GW Parkway Safety Study Comments from:  
Jim Klein  
Trails, Sidewalks and Bikeways Committee  
Mt. Vernon Rep  
703-650-8153

In 2011 at Vernon View: workday ADT of 692; weekend ADT of 1488

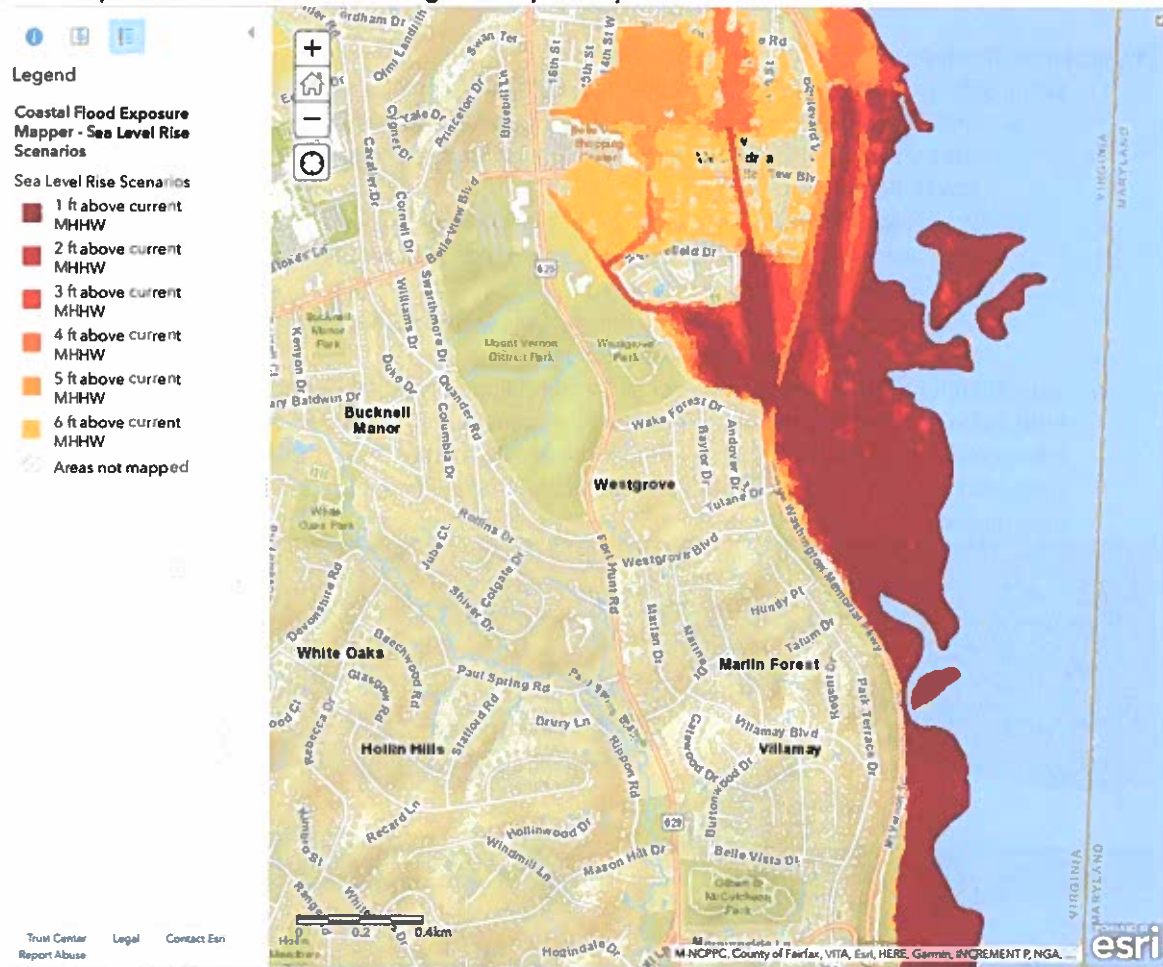
- 3) Need better information about trail user characteristics as shown on the DISPLAY BOARD: [GWPKWY Boards\\_7.10.197.jpg](#) which are inaccurate. The daily bicycle and pedestrian counts are low – when was this data collected? Weekends have very high daily usage – here is a link to stats from 2010-2011. I am sure there are more recent ones, but the paid consultant should be providing this information. If all they did was take one snapshot of use on a single weekday, that is not an accurate picture of the use of that trail.

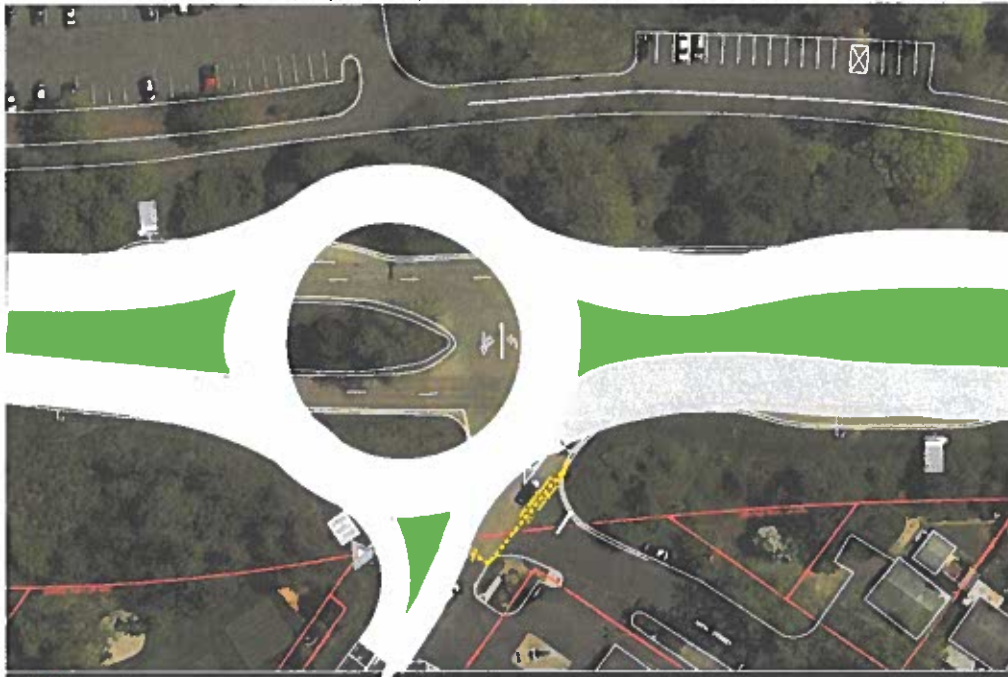
Below is a map showing the “bathtub” model of showing inundation for each foot of sea level rise. The dark red areas show just one foot of rise which would start to inundate the parkway on a

permanent basis. This also corresponds to the visual evidence of the permanent sea level rise that has already occurred where the trail gets regularly inundated and MHHW levels are already at the top of existing culverts. One foot of rise also has significant implications for flood hazard risks and storm surge.

If no flood mitigation work is done, then the Parkway will likely flood at greater and greater frequencies with sustained damage to the parkway itself.

George Washington Memorial Parkway  
at Belle Haven Road

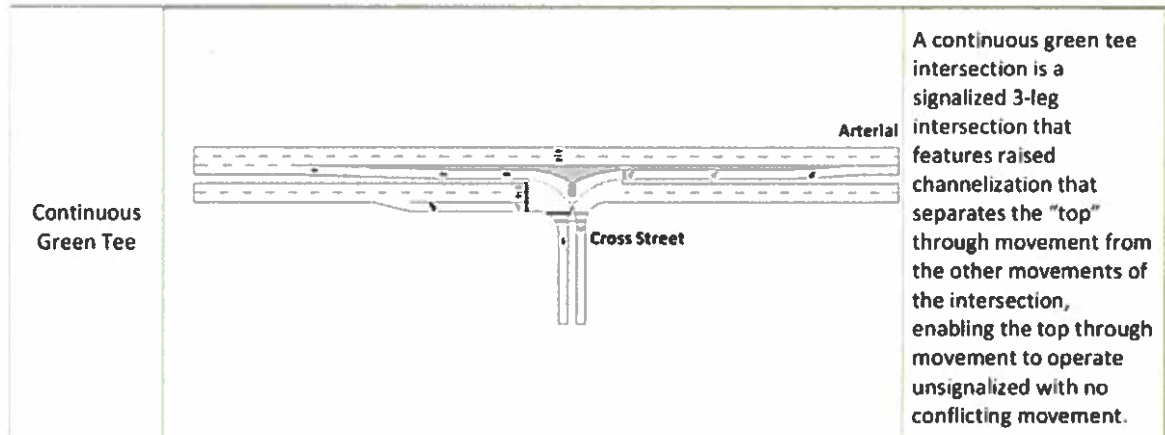
- c. Other intersections as deemed appropriate where at least one car storage at the median is needed to increase safety of crossings
- 2) Roundabout option – please consider the potential for a roundabout at the Belle Haven Road intersection as a way to handle the left turning movements and to serve as a traffic calming intervention (as speeds through a roundabout are 25 mph or less). The diagram below shows a roundabout with two lanes in both directions and the one lane each direction at the Belle Haven intersection—the entry to the park could be moved over to be the 4<sup>th</sup> leg of the roundabout
